ADDENDUM NO.: THREE

DATE: March 4, 2015

PROJECT TITLE: **OUTDOOR EVENTS SHELTER**
UNC CHARLOTTE
SCO ID# 14-11196-01A
WTS Project No. 1432/ File 7.0

WRITTEN BY: Michael Watson, AIA, LEED AP BD+C

DOOR
SCHEDULE,
DOOR DETAILS
AND FINISH
SCHEDULE

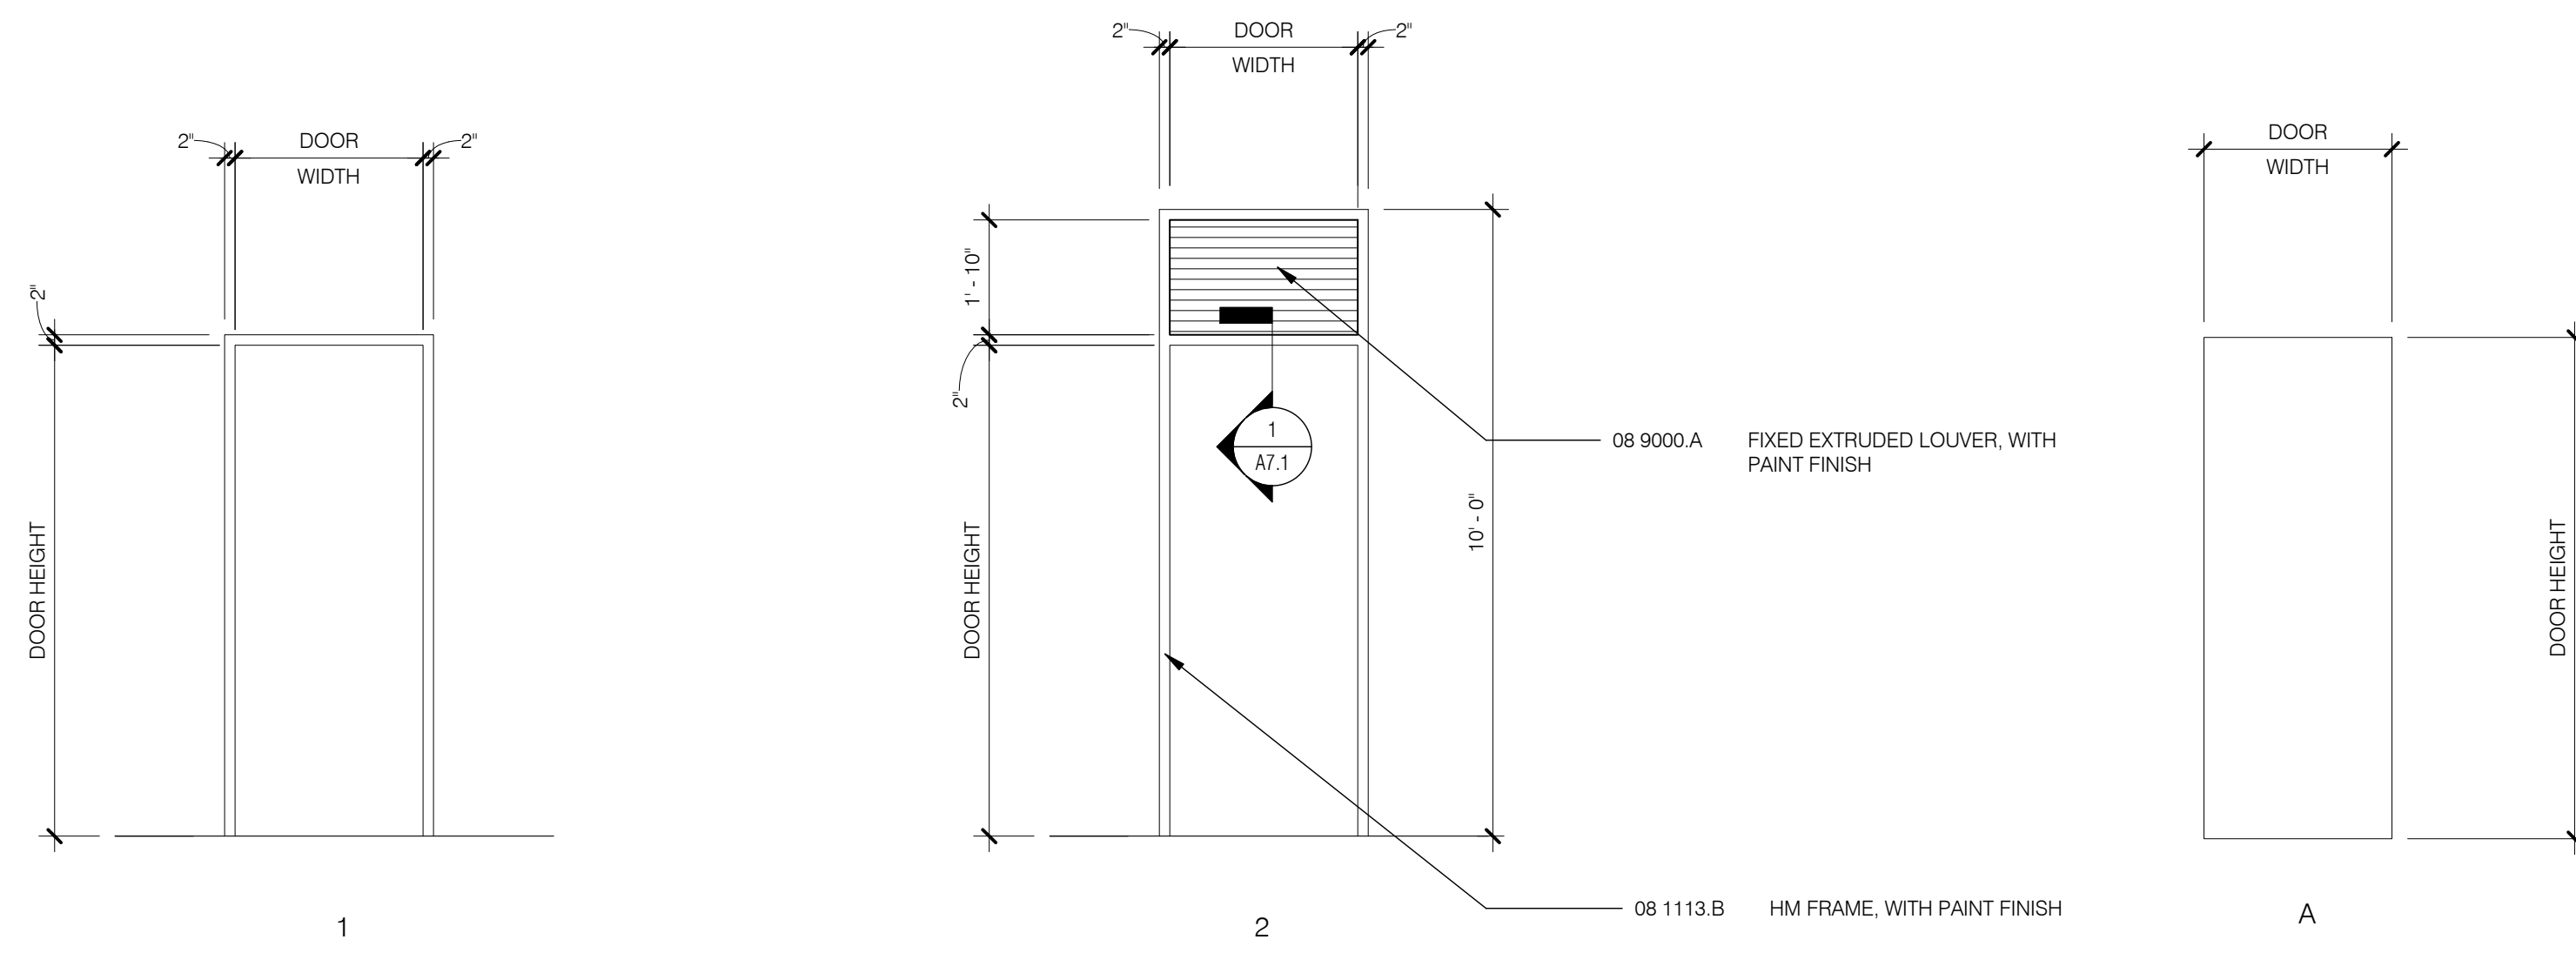
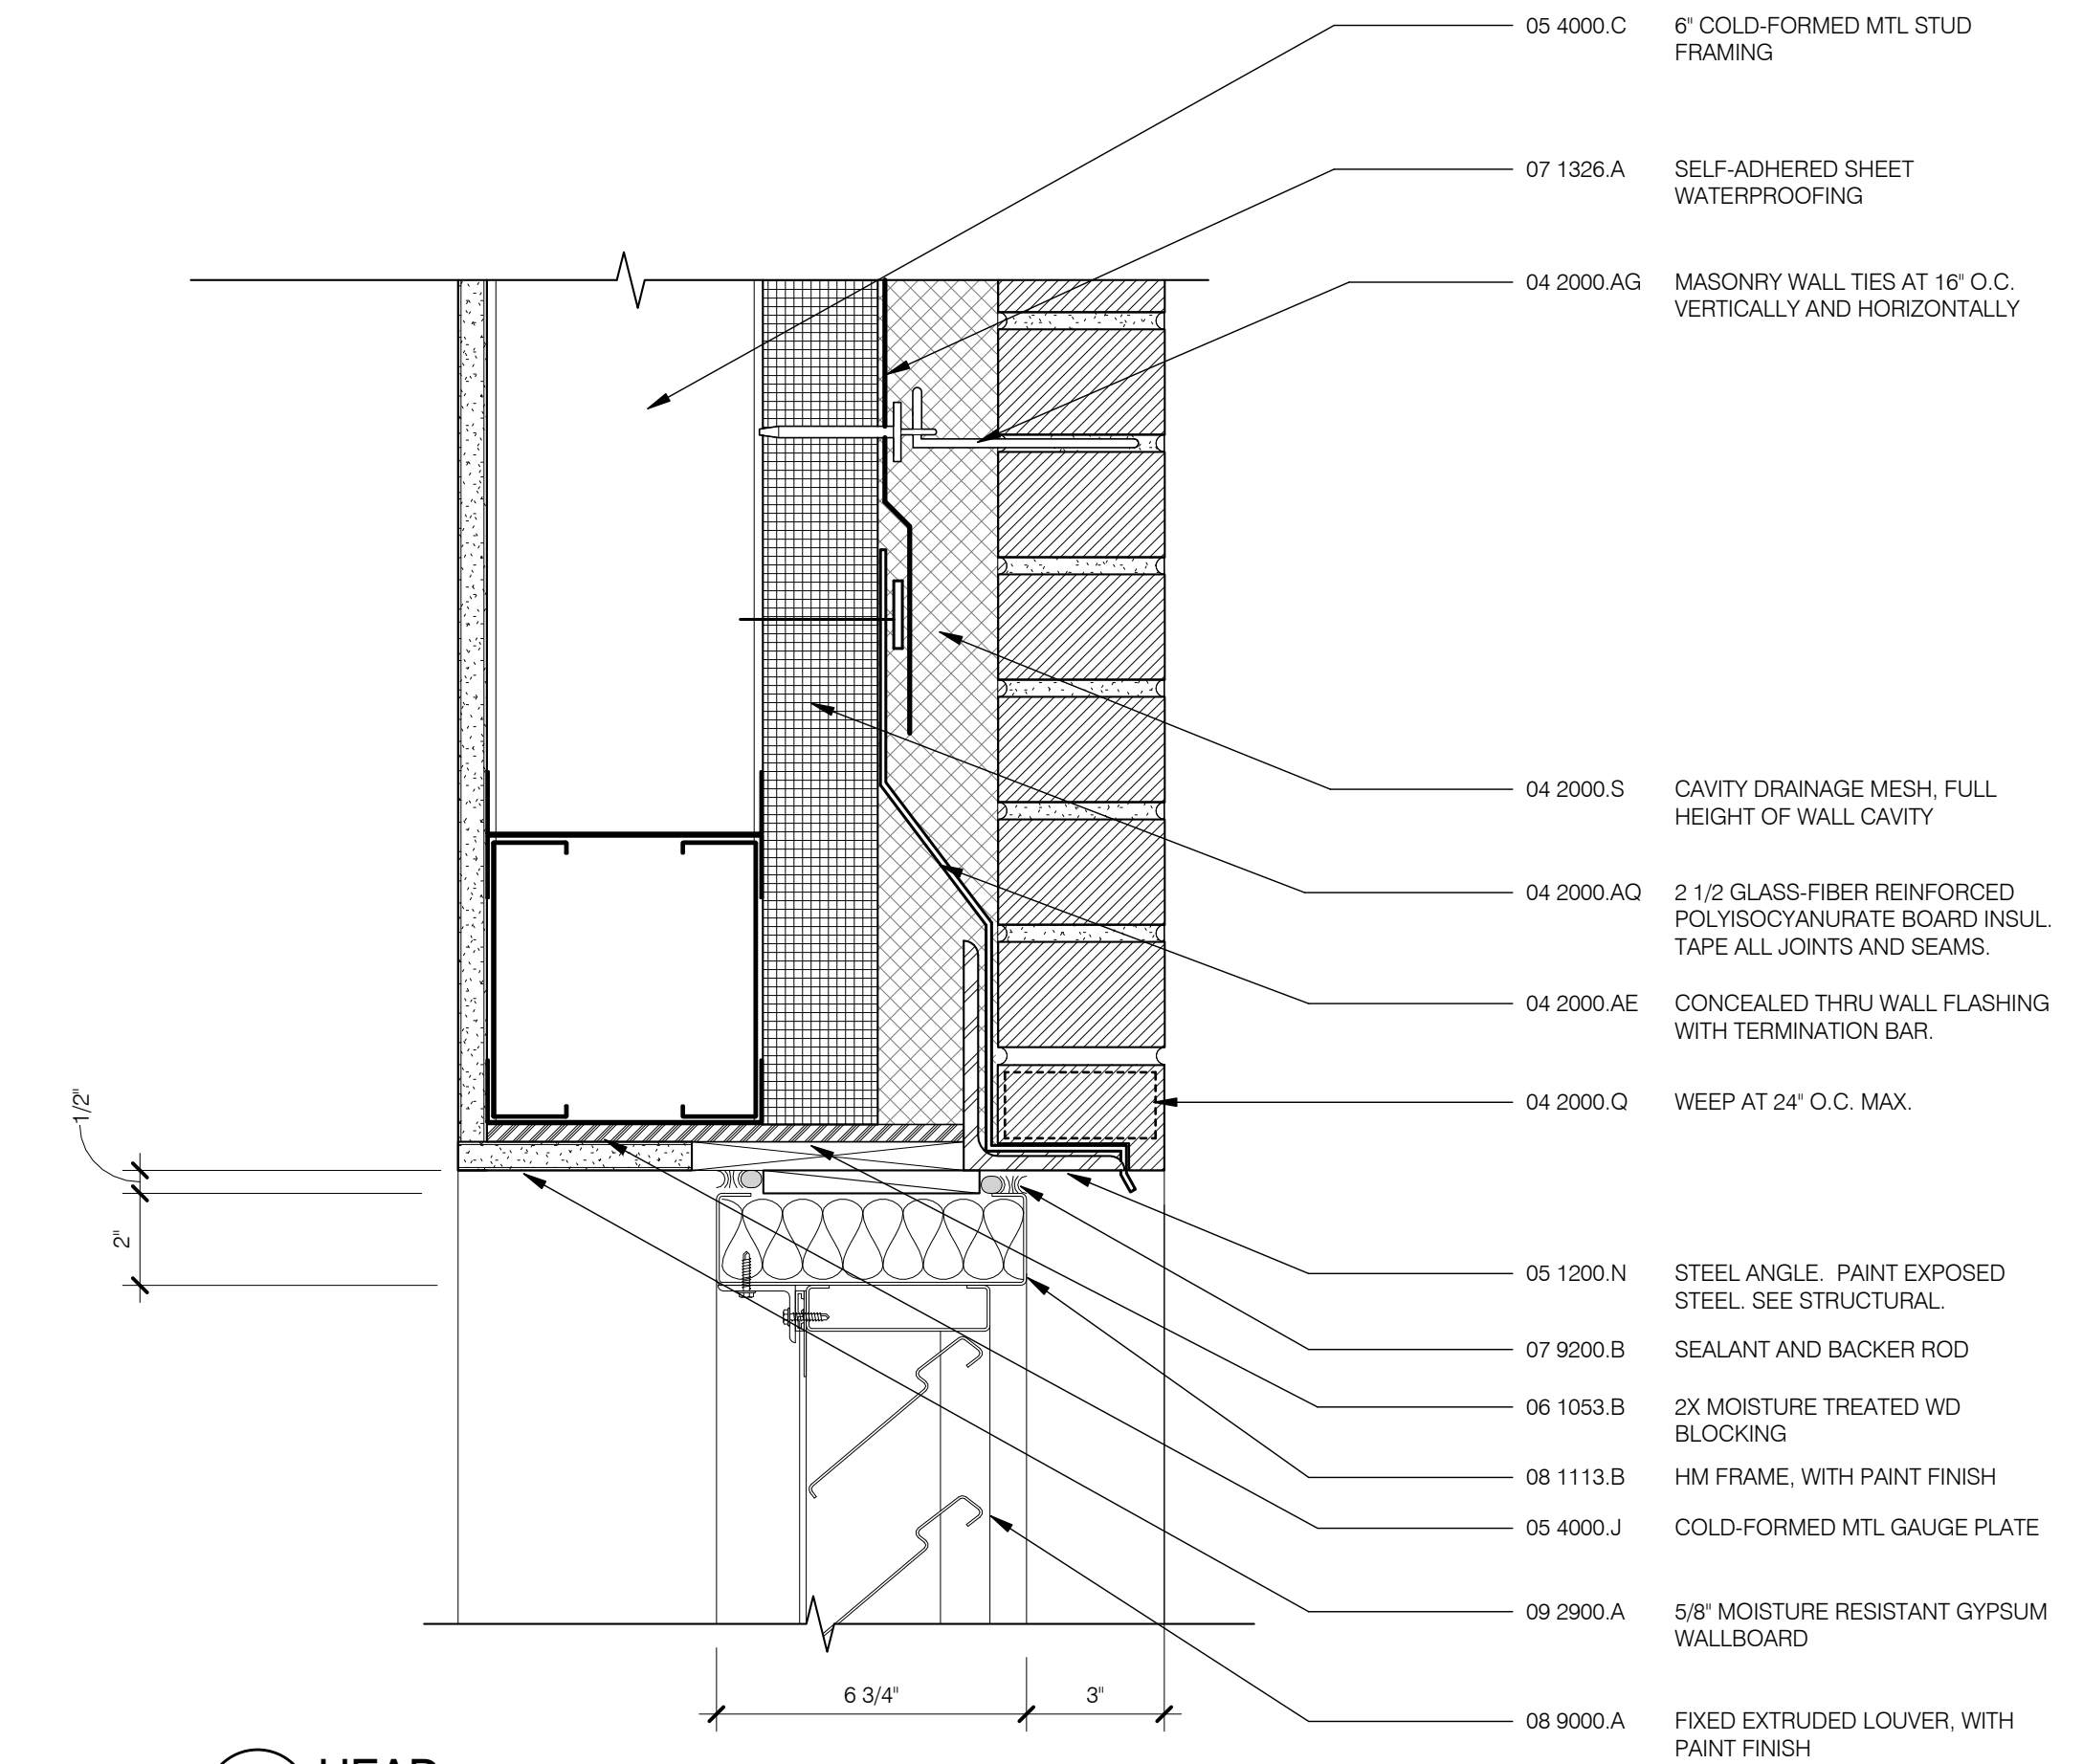
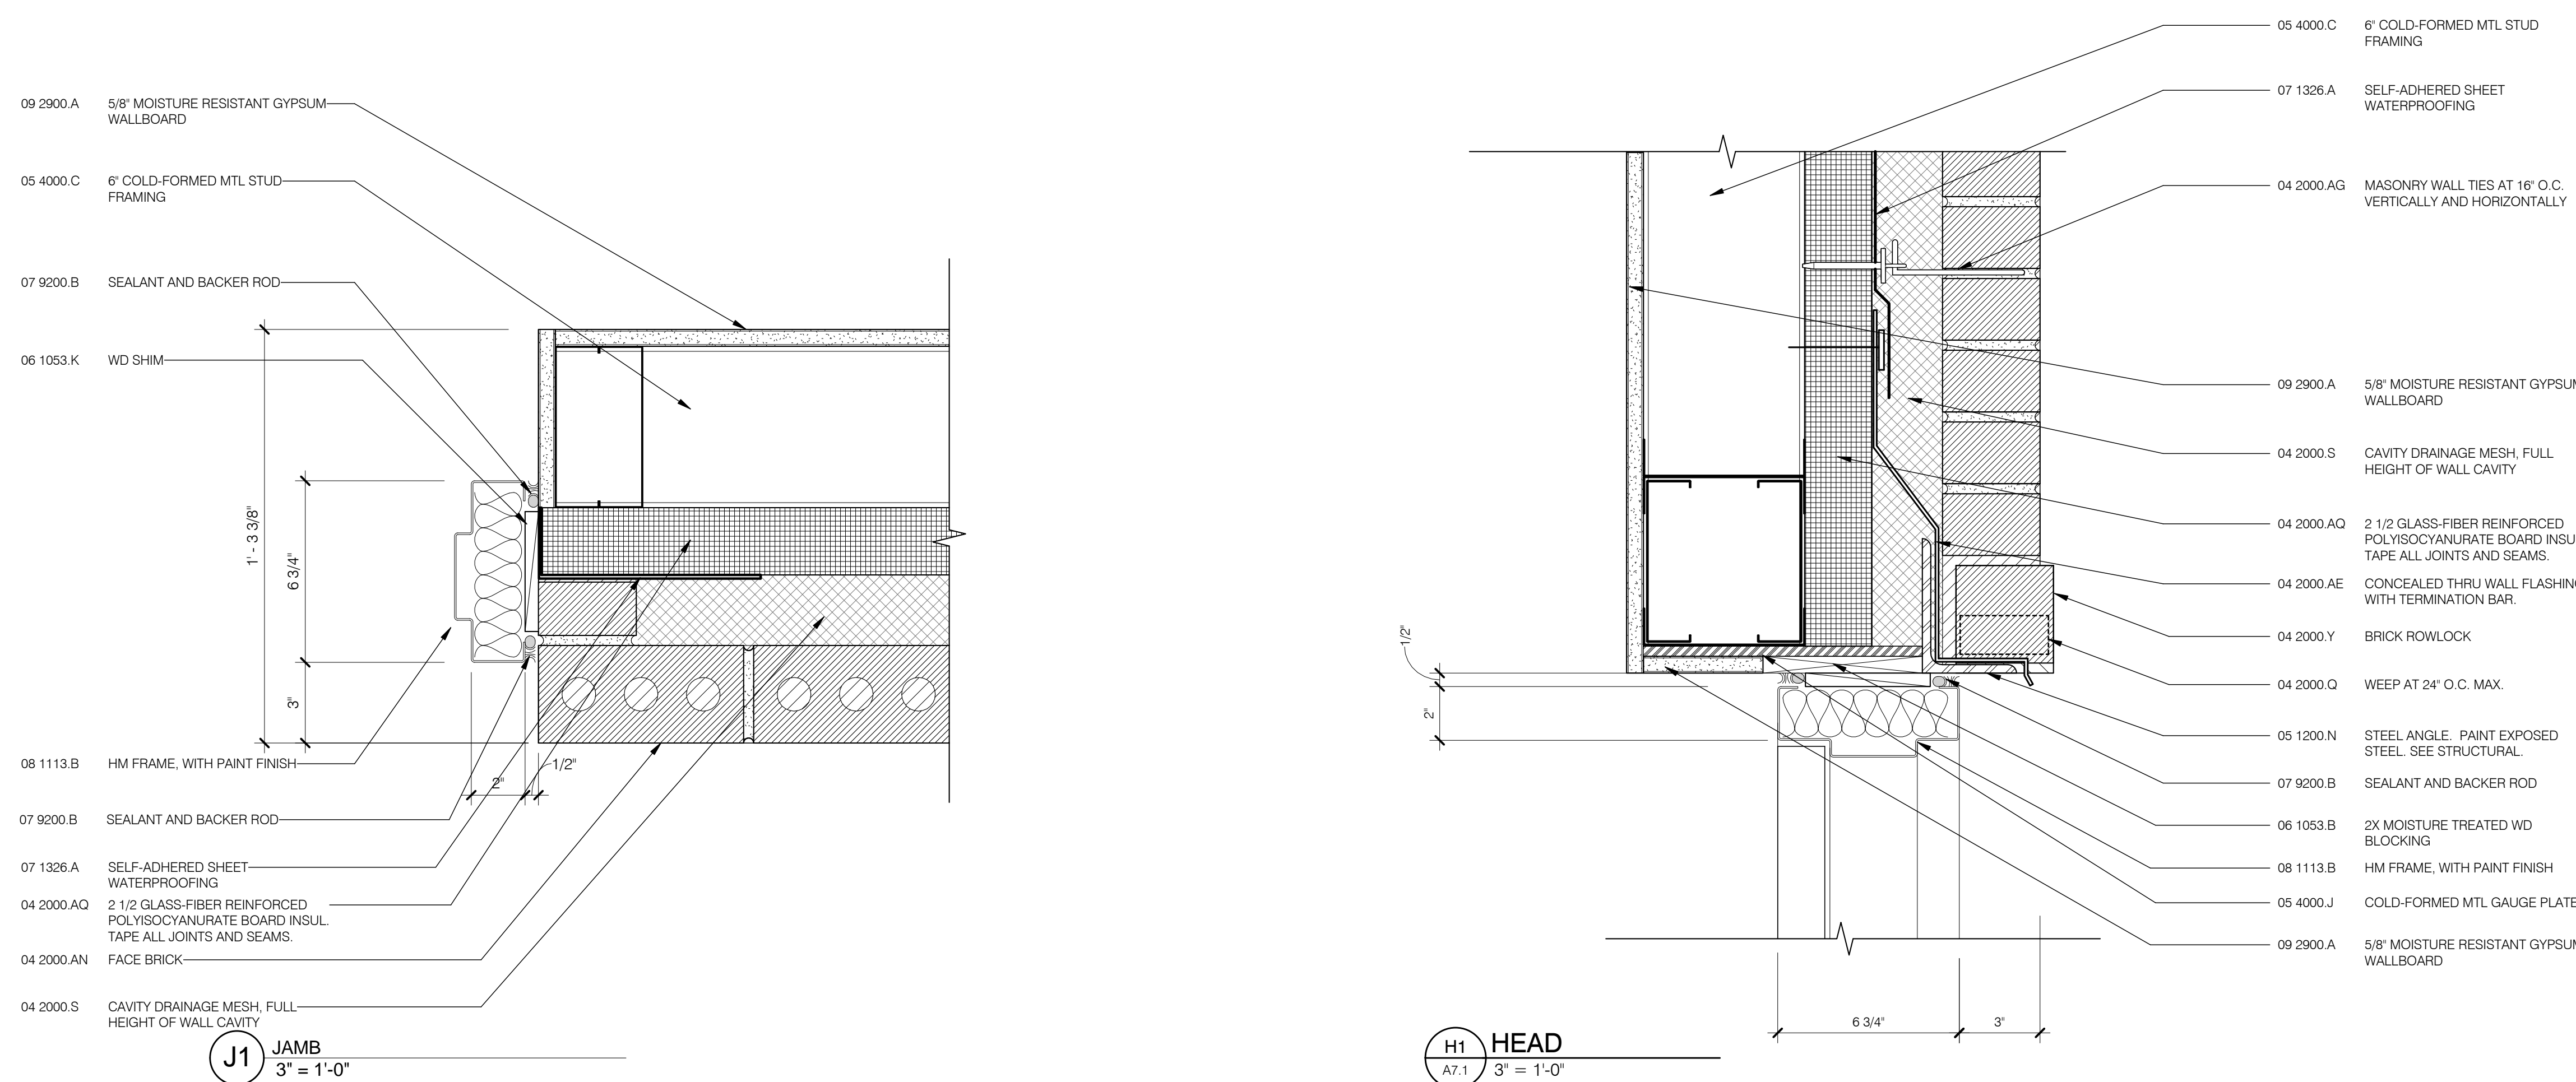
A. Finish Schedule was revised.
